## Design Changes Matrix

This is the Ground Floor presented to Councillor on 25th Feb 2021

This is the Upper Floor presented to to Community Presentation Day on 13 & 20 April 2021 and Pre DA

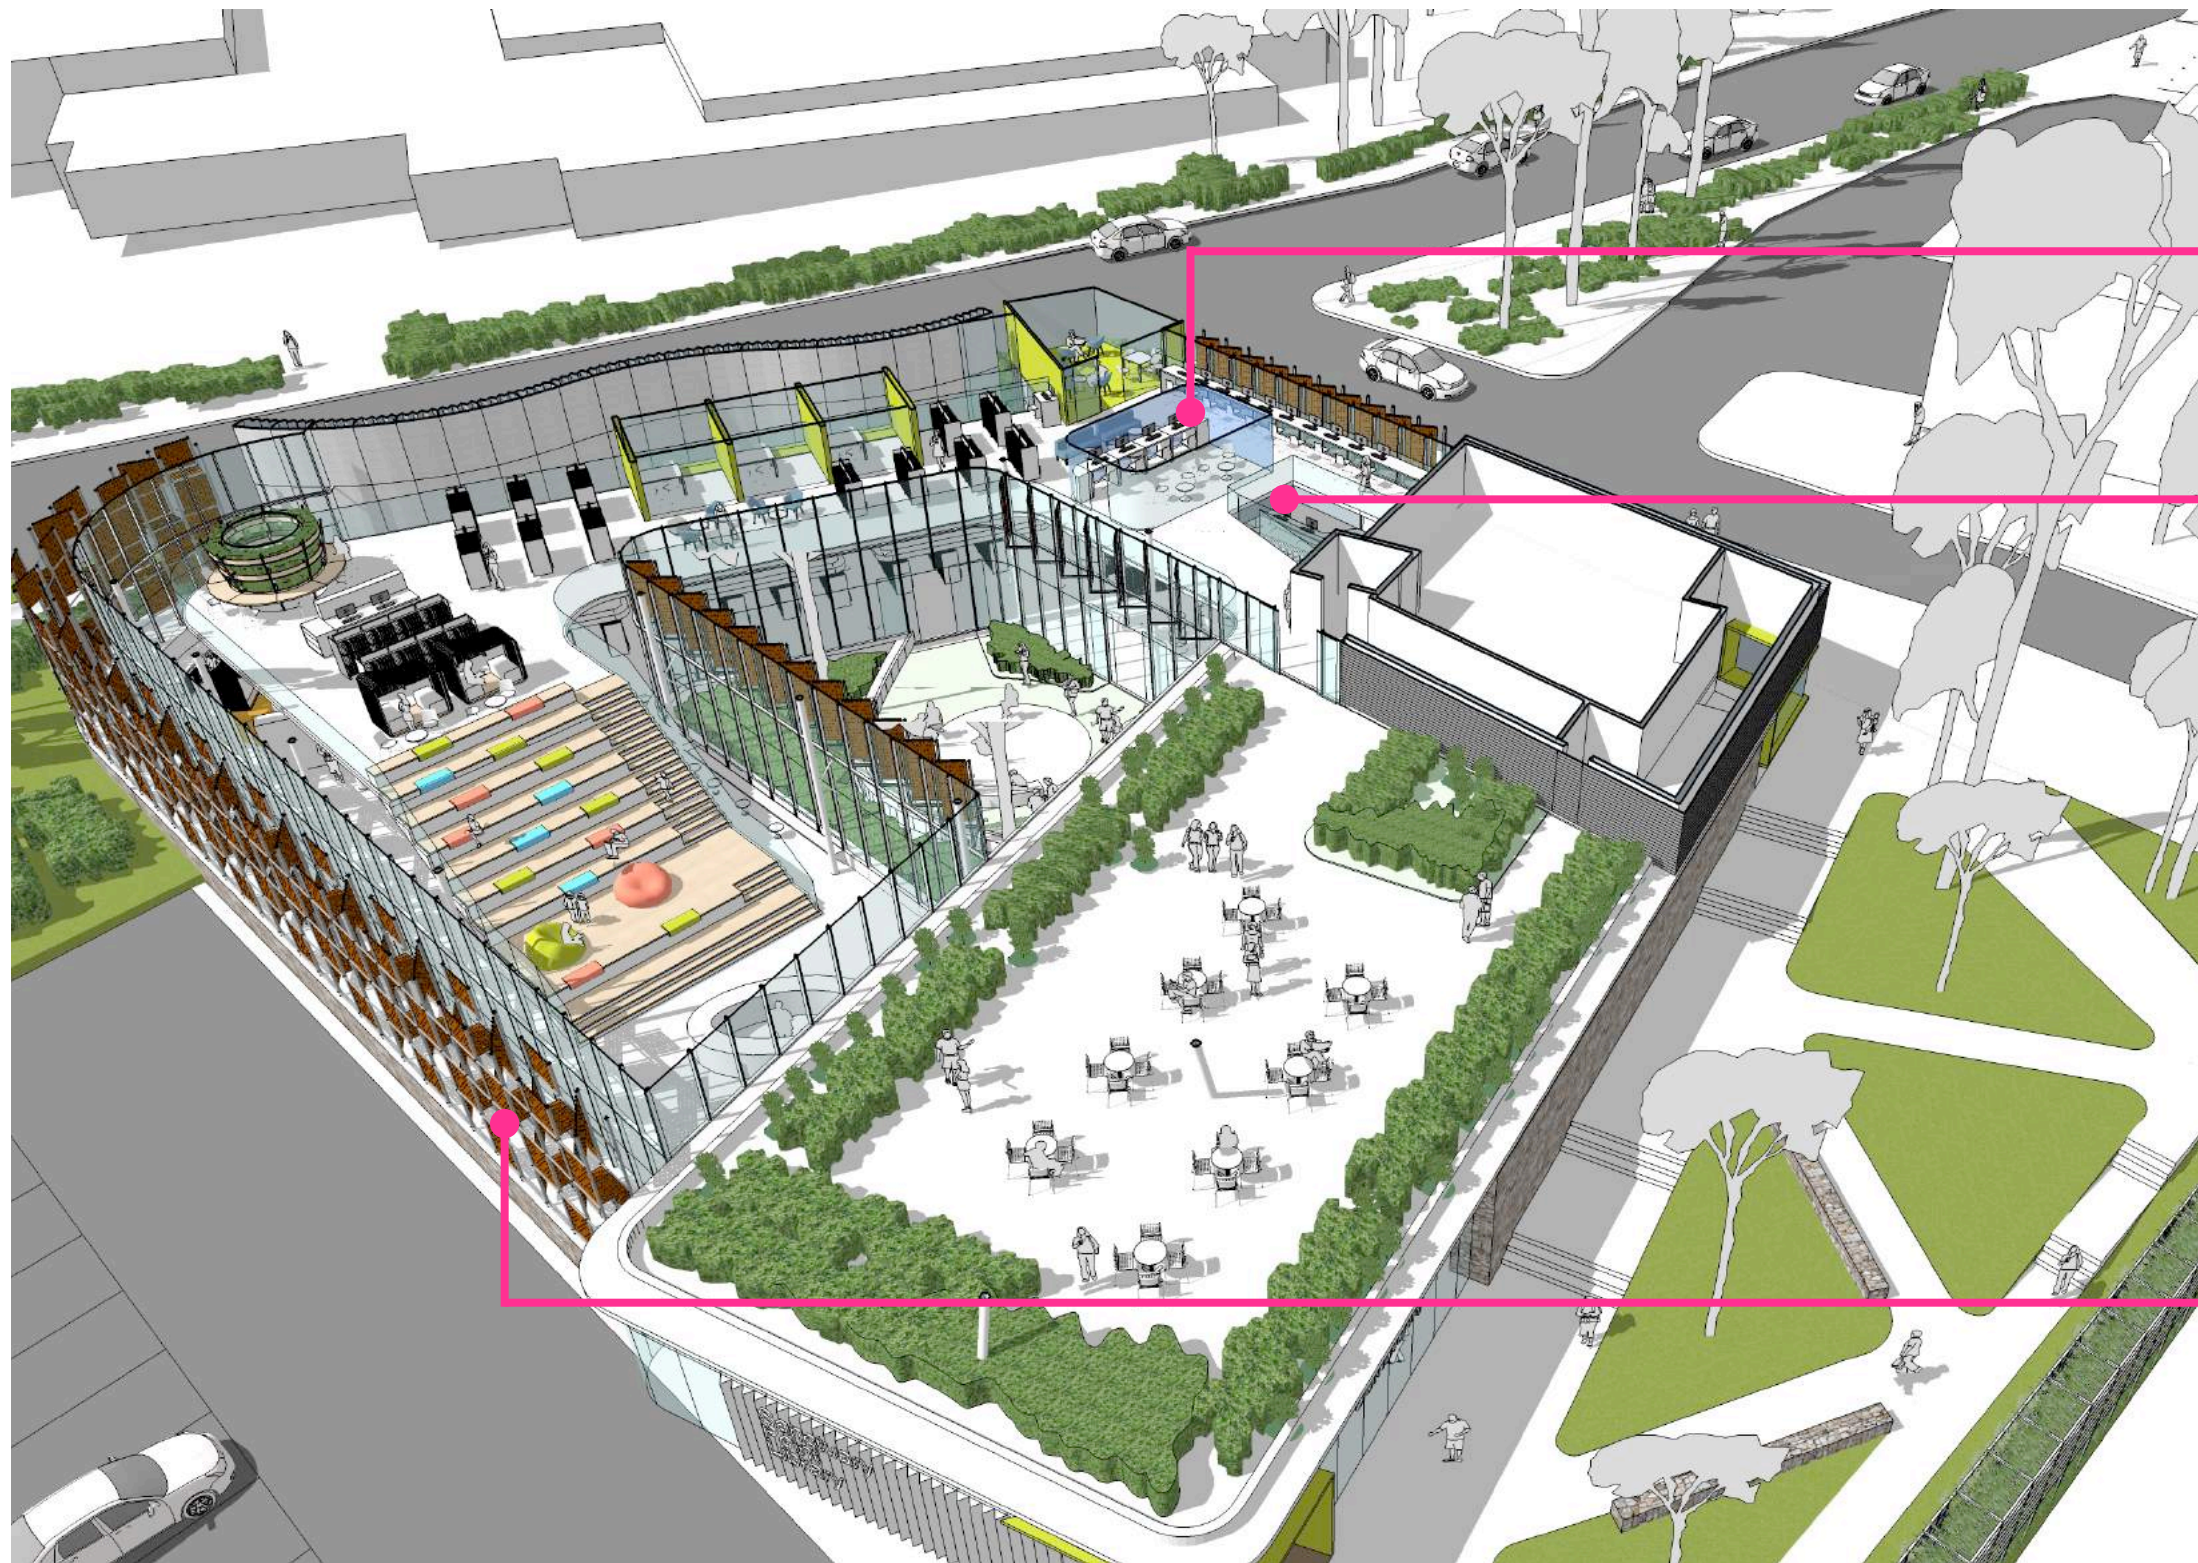
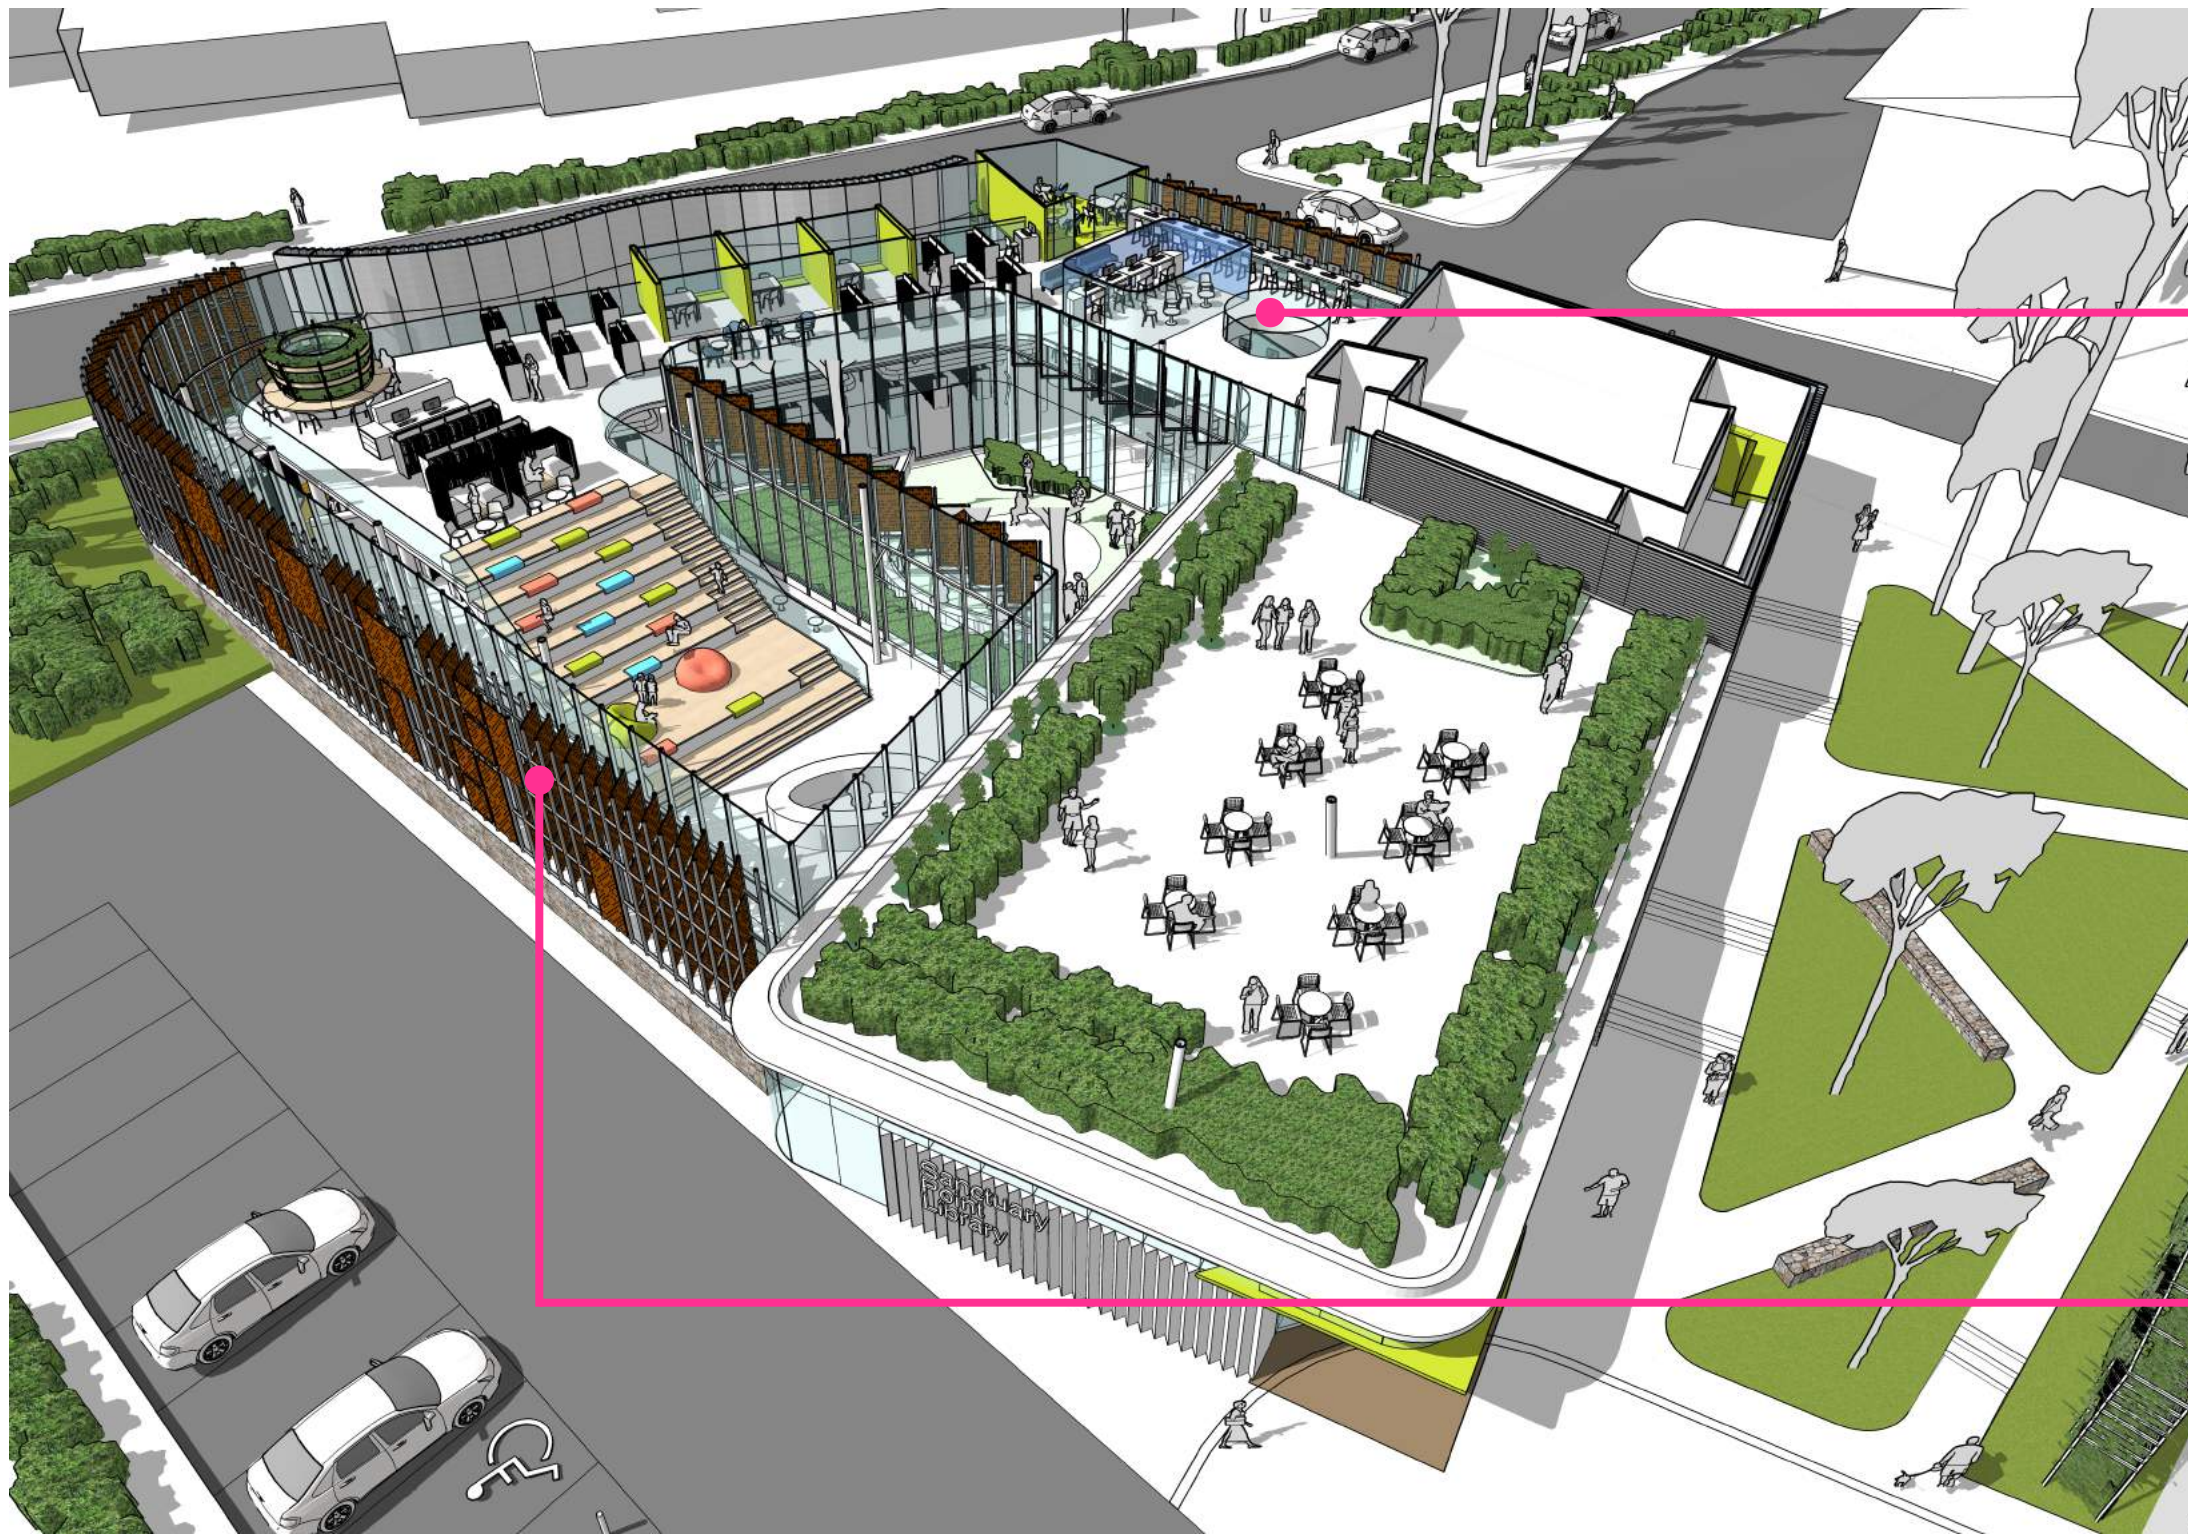
Research Room relocated to make way for new location of Stairwell in the Community Presentation Documents & PreDA Documents

Stairwell relocated to assist with mechanical reticulation in the Community Presentation Documents & PreDA Documents.

Breakup of the sunshade modified in coordination with graphics strategy for artwork in the Community Presentation Documents & PreDA Documents
